AS-BUILT MAY 2009
 TO THE BEST OF OUR KNOWLEDGE CORWIN ENGINEERING, INC., HEREBY STATES THAT THIS PLAN IS AS-BUILT, THIS INFORMATION PROVIDED IS BASED ON SURVEYING AT THE SITE AND INFORMATION PROVIDED BY THE CONTRACTORS.

DEVELOPMENT PLANS FOR
STONE CREEK PHASE I
 ROCKWALL, TEXAS

GRADING PLAN

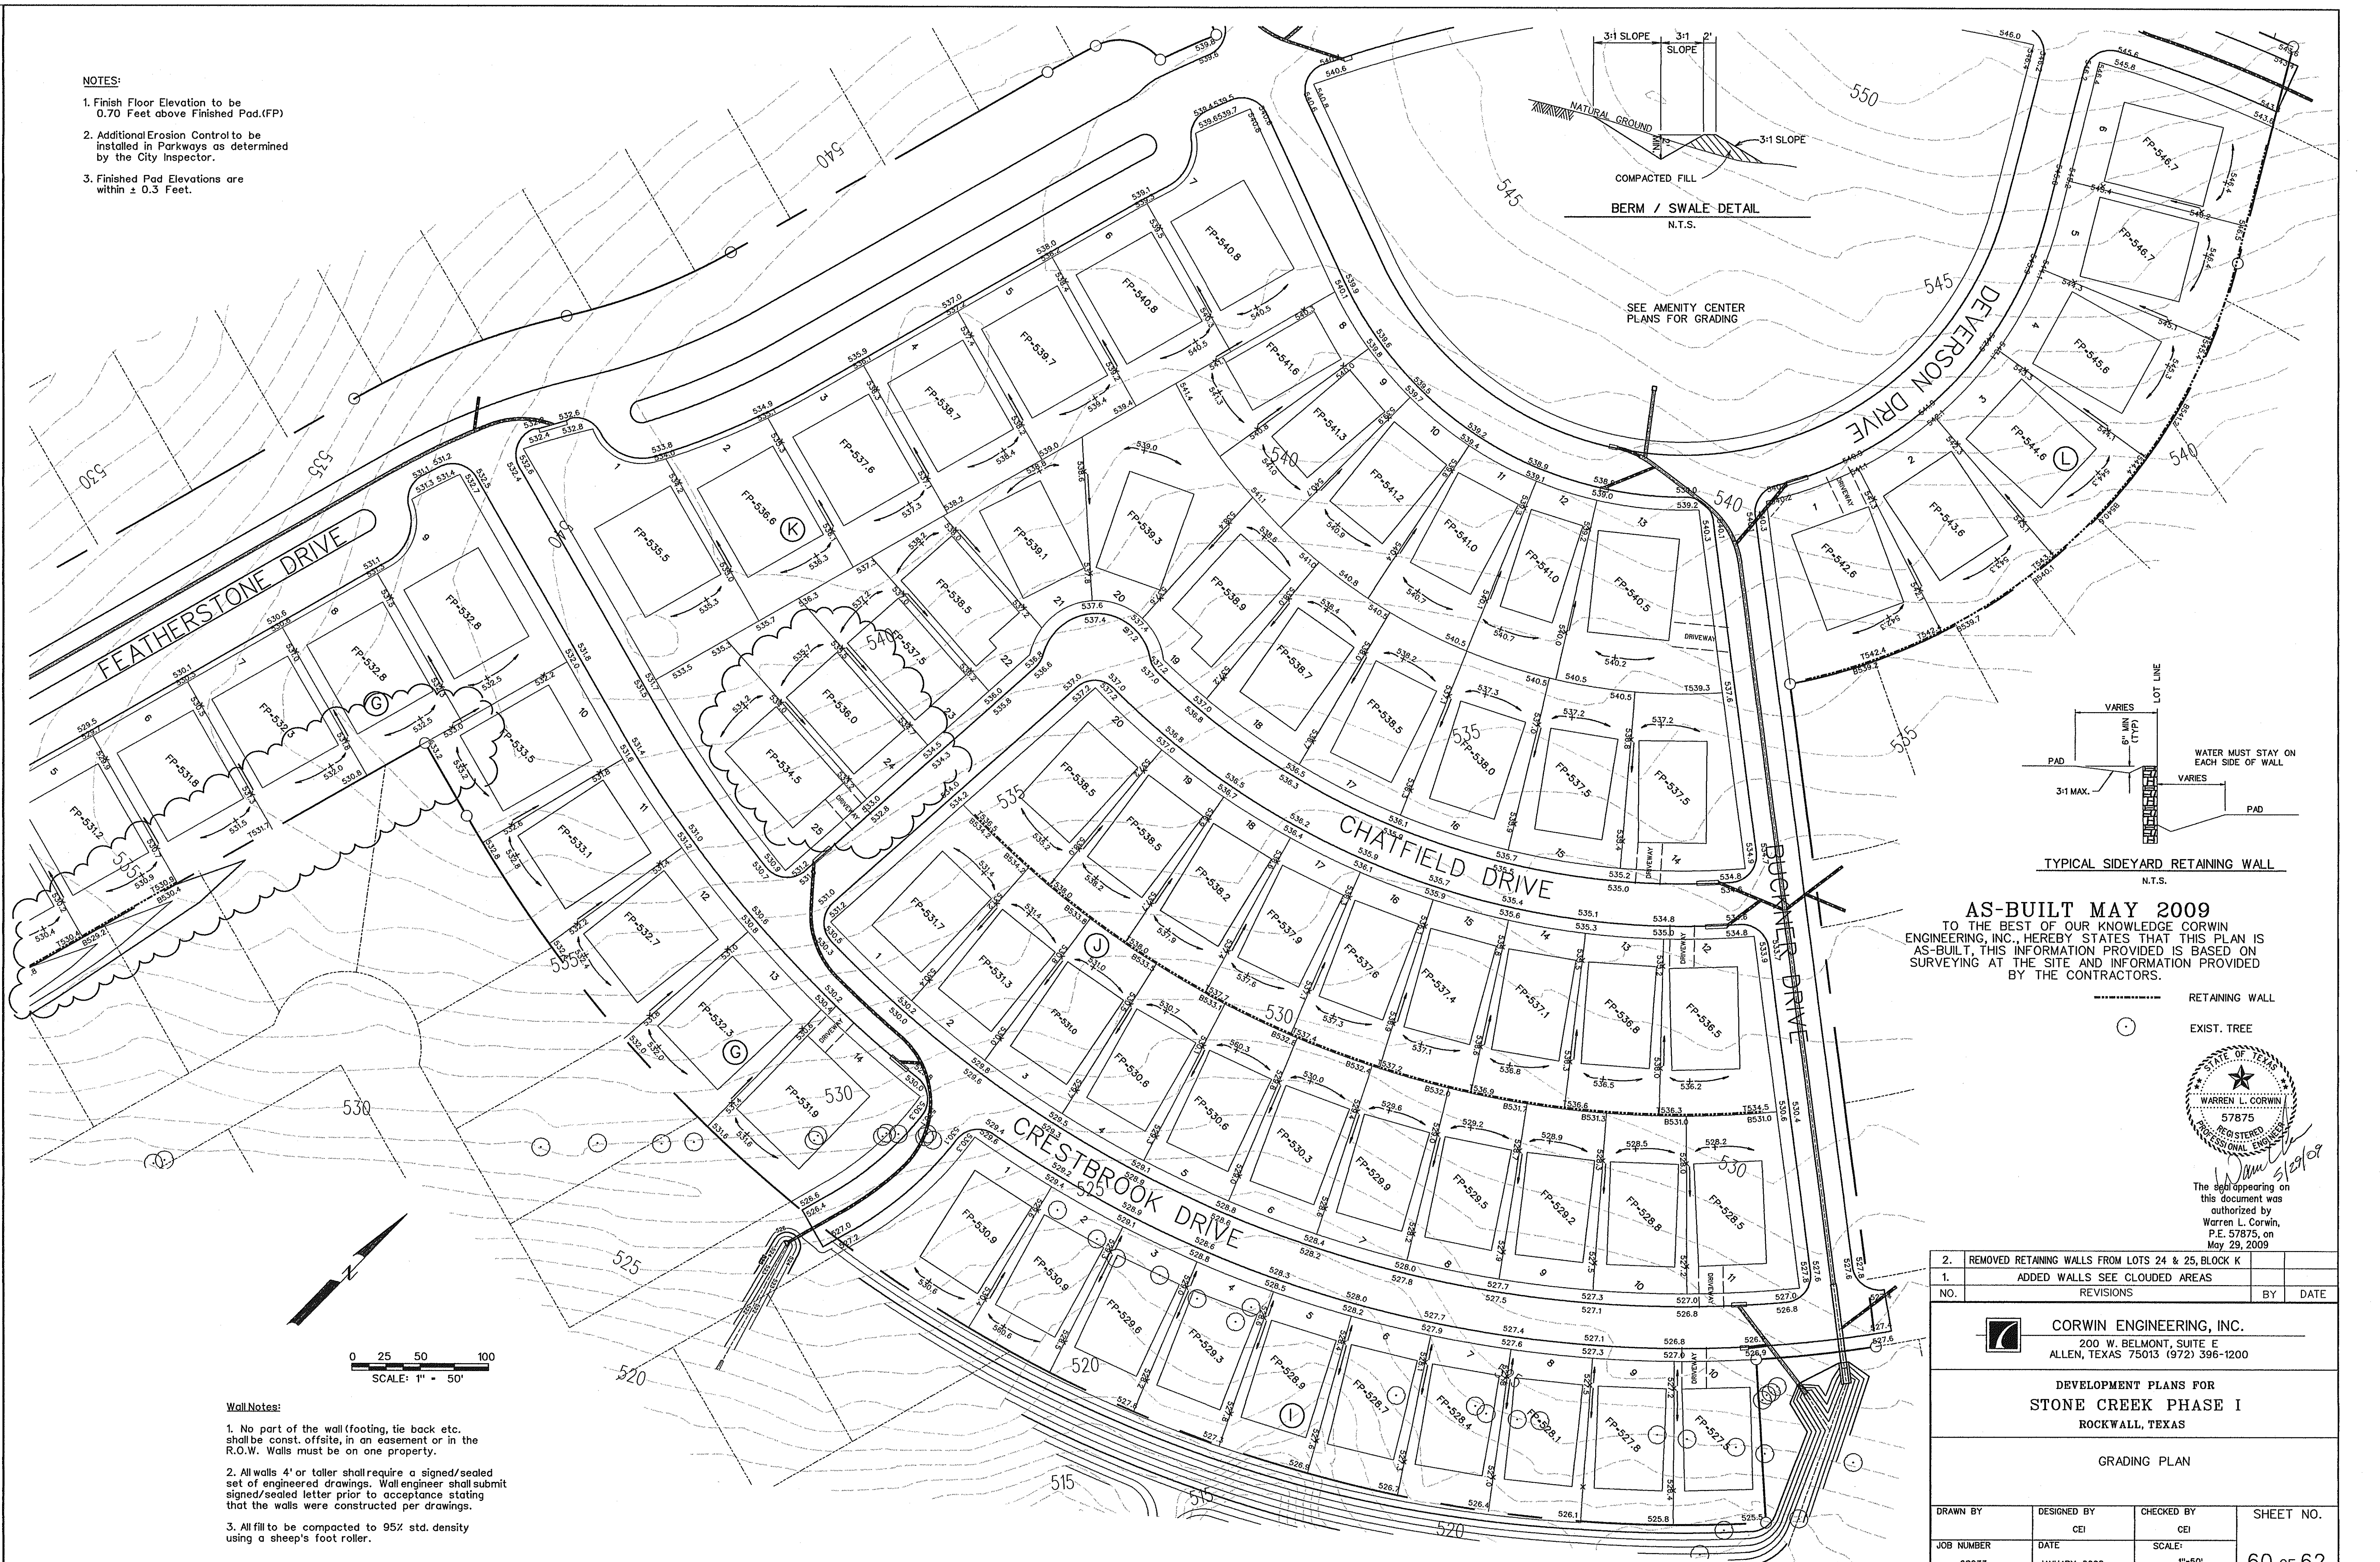
2.	REMOVED RETAINING WALLS FROM LOTS 24 & 25, BLOCK K		
1.	ADDED WALLS SEE CLOUDED AREAS		
NO.	REVISIONS	BY	DATE
